RE: 16-ZN-2020
Greystar Active Independent Living Rezoning
6L845 (Key Code)

The Planning & Development Services Division has completed the review of the above referenced development application submitted on 10/20/20. The following **1st Review Comments** represent the review performed by our team, and is intended to provide you with guidance for compliance with city codes, policies, and guidelines related to this application.

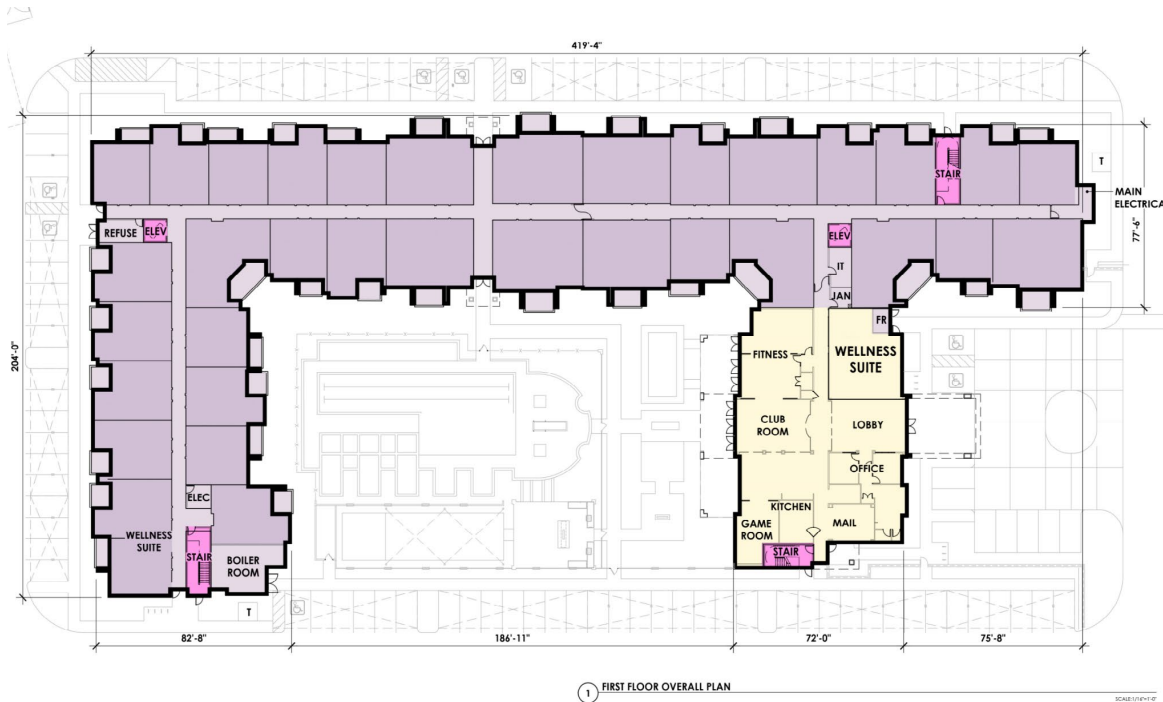
1. The proposed project appears to be an age-restricted multi-family residential community and not a residential healthcare facility. The project narrative provides no mention of on-site care or licensing of the facility by the State. In addition, the site plan provides no services such as central dining. Multi-family residential is not a permitted land use within the Commercial Office (C-O) zoning district. Please revise the project plans and narrative to address the land use restrictions of the C-O zoning district, or alternatively, submit an application for rezoning of the site to a zoning district that permits multi-family residential (Zoning Ordinance, Sec. 11.201.)

Zoning Ordinance Definition:

Minimal residential health care facility shall mean a residential health care facility which provides resident rooms or residential units, and may include independent living units and such services such as central dining, transportation and limited medical assistance.

Greystar:

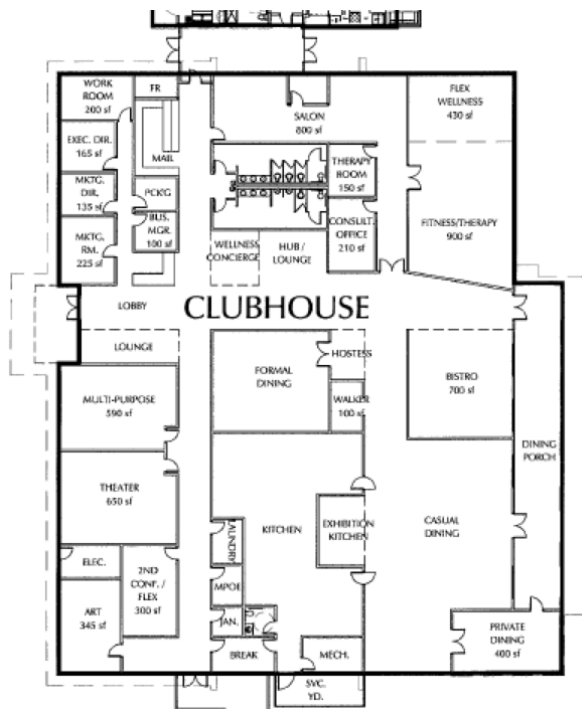
The minimal residential health care facilities we have been processing have had central dining and large kitchen areas. Offices were also more apparent in the other facilities for care services. Below is the difference in floor plans:
